REQUEST FOR DEVIATION/WAIVER (RFD/RFW)

10. TITLE OF DEVIATION/WAIVER: REQUEST FOR WAIVER FOR BARREL WRENCH P/N-3269541

11. CONTRACT NO. AND LINE ITEM: DAAE20-01-P-0050, 001AA

13. CONFIGURATION ITEM NOMENCLATURE: WRENCH BARREL

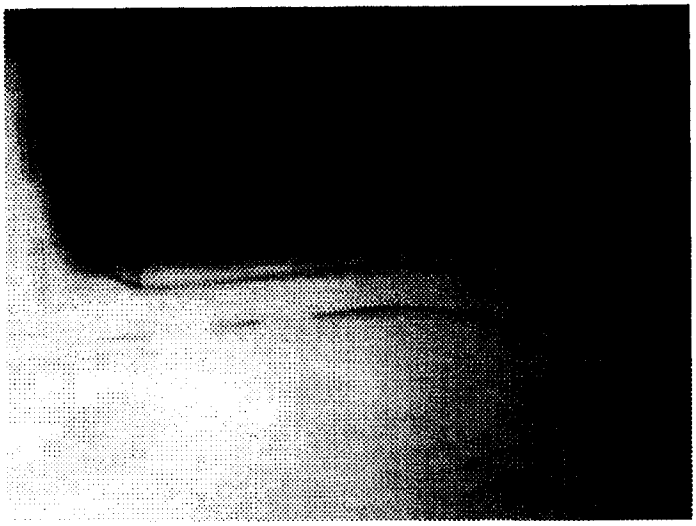
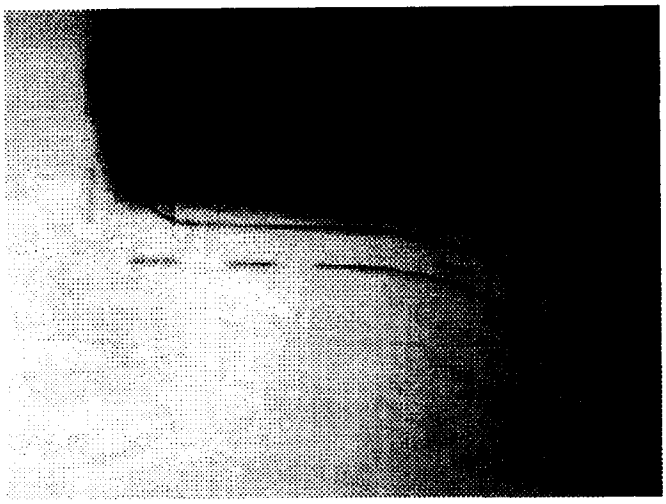
22. DESCRIPTION OF DEVIATION/WAIVER: .094 RADIUS (2) PLCS. UPPER RADIUS IS ABOUT .010 SMALLER. AND DOES NOT EFFECT THE FUNCTION OF THE PART.

23. NEED FOR DEVIATION/WAIVER: PER E-MAIL FROM CONTRACT SPECIALIST DATED 28 NOV. 01. TROOPS HAVE NO PARTS IN STOCK. THESE ARE NEEDED FOR DEPLOYING TO THE MIDDLE EAST. RADIUS WAS PARTIALLY CUT-OFF BY THE FOUNDRY. FOUNDRY HAVE BEEN NOTIFIED.

24. CORRECTIVE ACTION TAKEN: QUANTITY AVAILABE FOR SHIPMENT IS 568 PCS. REMAINING BALANCE OF 32 PCS TO BE CORRECTED BY FOUNDRY WITHIN REQUIRED DIMENSIONAL SPECIFICATION.

b. APPROVAL: w/mod [X] APPROVED [ ] DISAPPROVED
